ANADROMOUS WATERS CATALOG/ATLAS
CORRECTION FORM

Map: Dixon Entrance D-3

Water Body Number: 103-30-10380

Nomination Number: 08-241

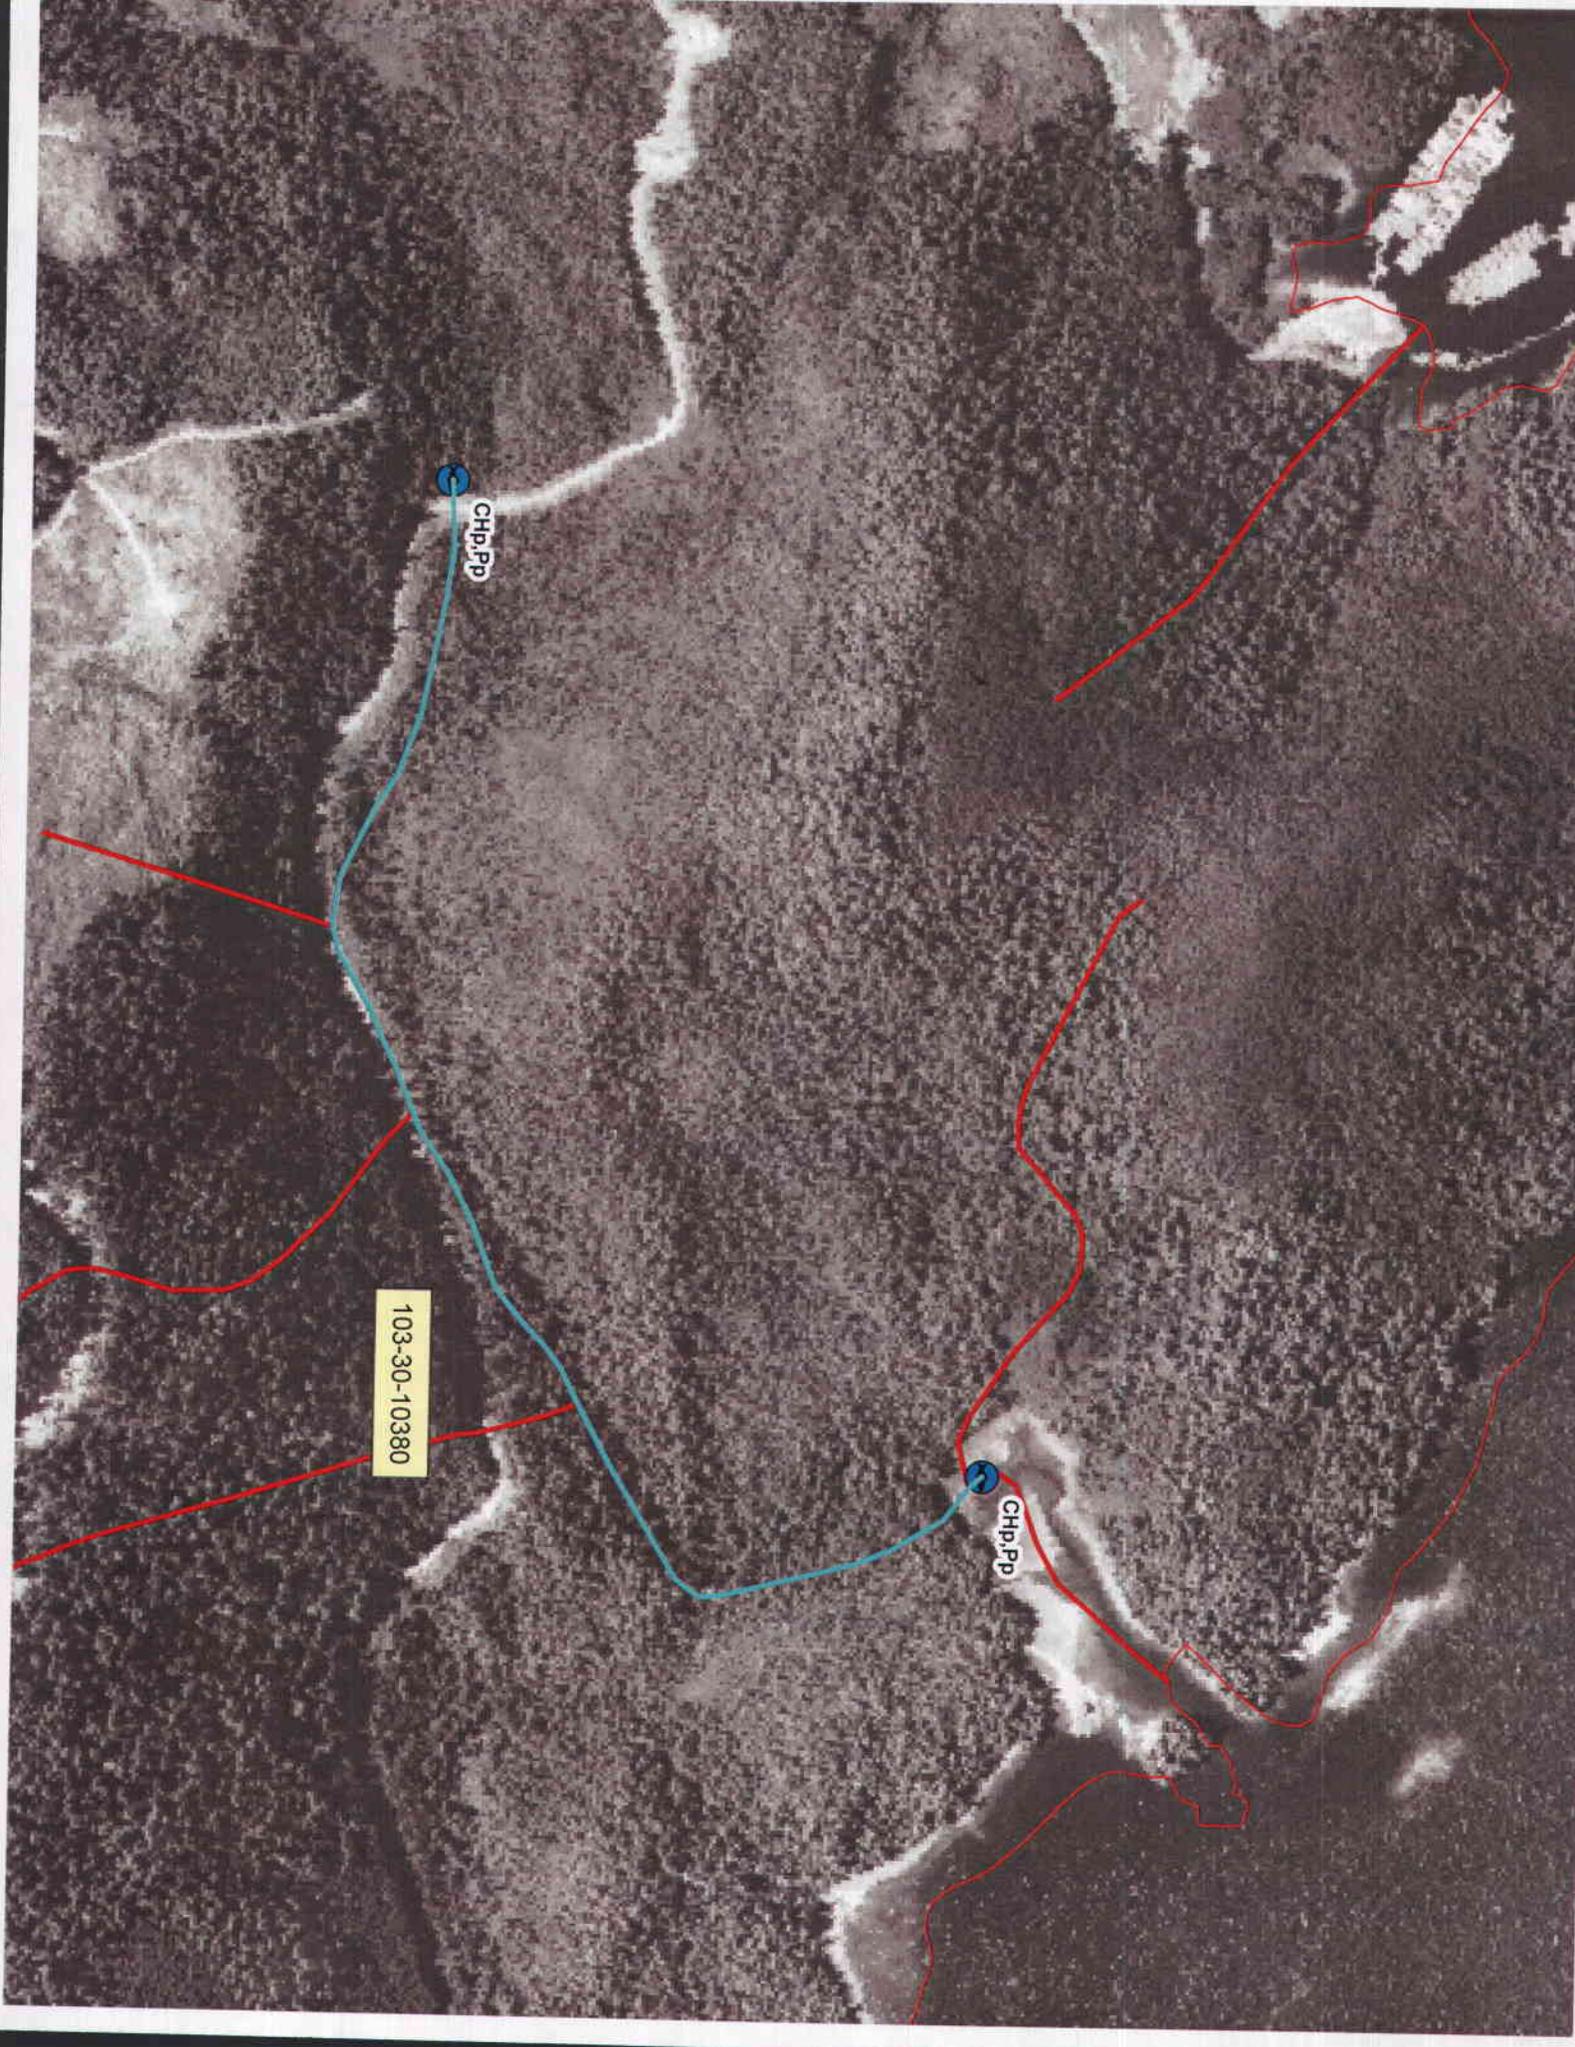
Describe Change(s): ~~Move stream arc to location as depicted~~

on map mylar, arc was moved in error

1998 NAD 27 lower pt 54° 54' 08" N, 132° 53' 52" W.

1998 NAD 27 upper pt 54° 54' 13" N, 132° 55' 05"W.

J,
I was on the ground on both streams last week. The stream to the north did not have any pinks in it and no signs of juvenile coho salmon. The stream to the south did have pink salmon in it up to the big bend. This stream is shown in Edgingtons report as fish habitat up to the bend where the stream gets steeper and the substrate changes to bedrock/boulders. I think, other than being cataloged to far upstream, the catalog is correct in showing the southern stream as the cataloged stream. I will put together a nomination form to get the situation straightened out. Thanks,

Attached pdf shows location of water body in question as currently mapped in AWC
I found older map that does show arc north of present mapped location
Looks to me that arc for -10380 was redrawn to match USGS NHD hydrography
But if you look closely there does appear to be a stream course in the approximate location of older arc
What do you think?
If ya want arc moved, now is the time.
